CORRIGENDUM - 05 TO NIT NO-66823

Subject: Corrigendum-05 to Tender enquiry for Pre-bid Tie up for Supply & Services of 230kV and 66kV GIS for CPCL Nagapattinam Refinery Project.

Project : CPCL Nagapattinam Refinery PROJECT
Equipment / Item : SUPPLY & SERVICES OF 230kV and 66kV.
Enquiry No/Date : 61Q2300095 Dated 16.07.2022
BHEL NIT NO : 66823
Original Tender due date : 18.07.2022

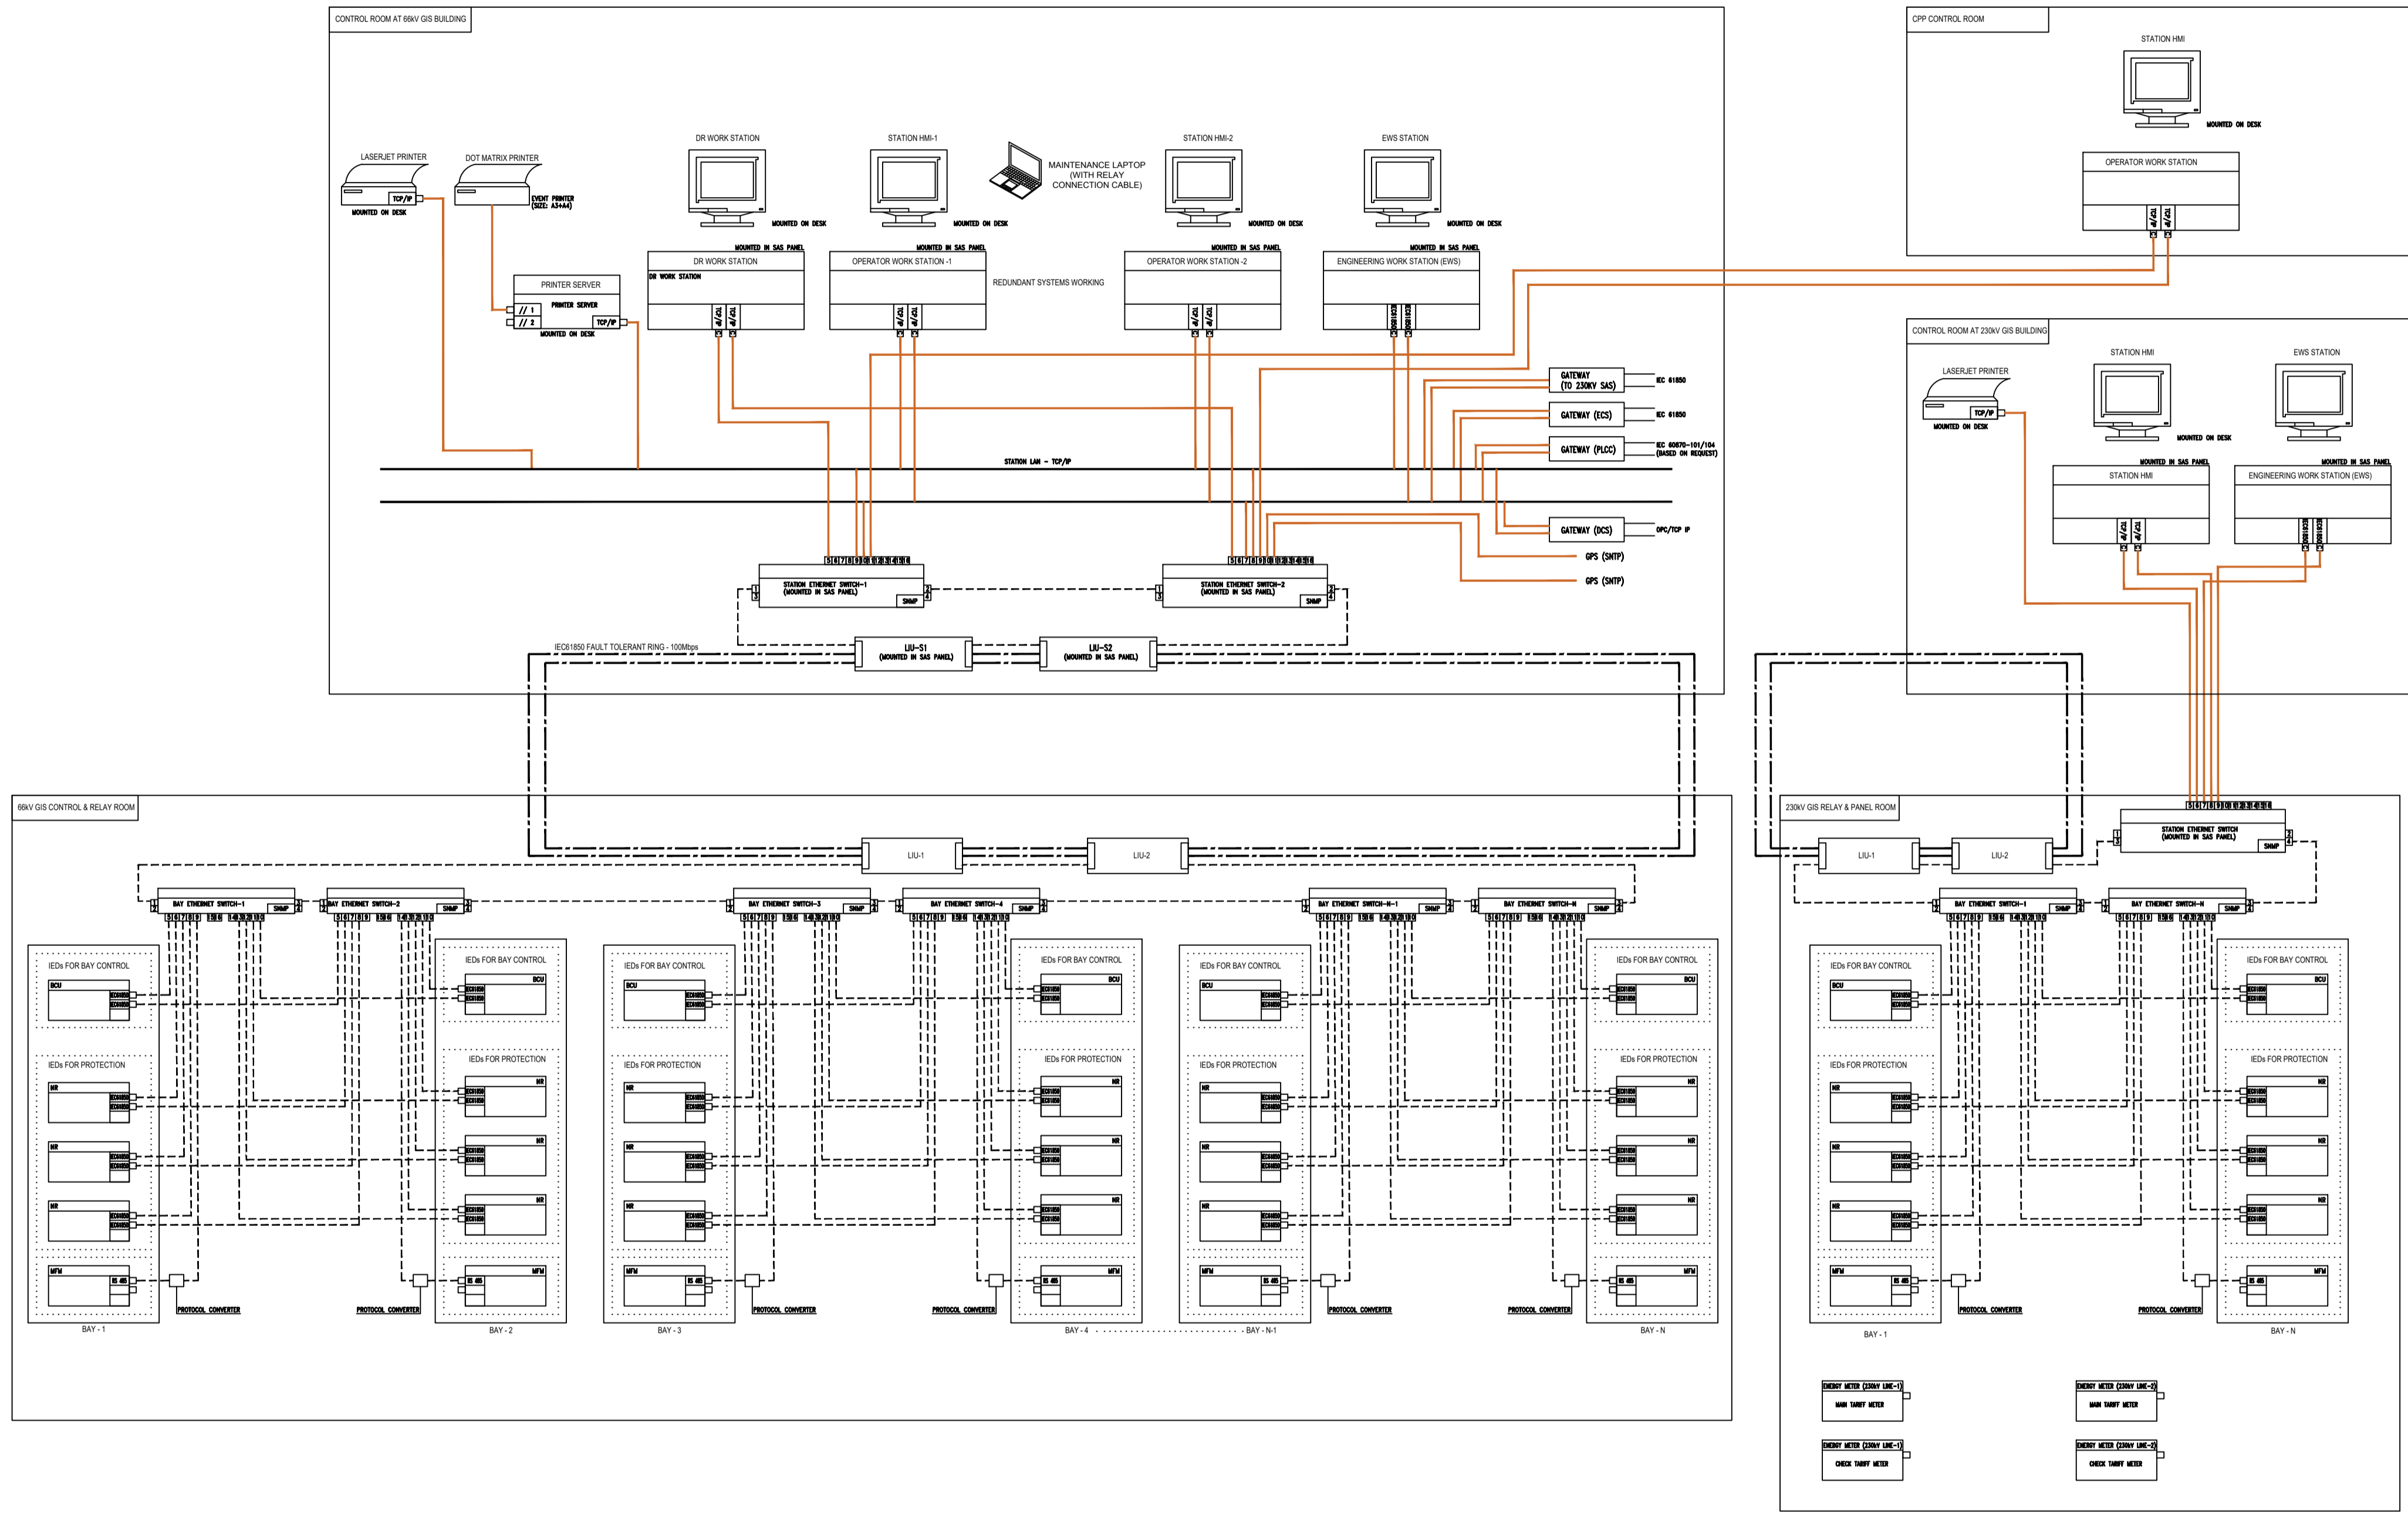
32.	VOLUME II	(PART-2 of 4) (Page No. 977 of 2608)	EXHIBIT-7	Substation Automation System (SAS) for 230kV & 66kV GIS	Modification of Substation Automation System (SAS) for 230kV & 66kV GIS (EXHIBIT-7): Exhibit -7 attached with Tender Specification is replaced. Refer Attachment -8
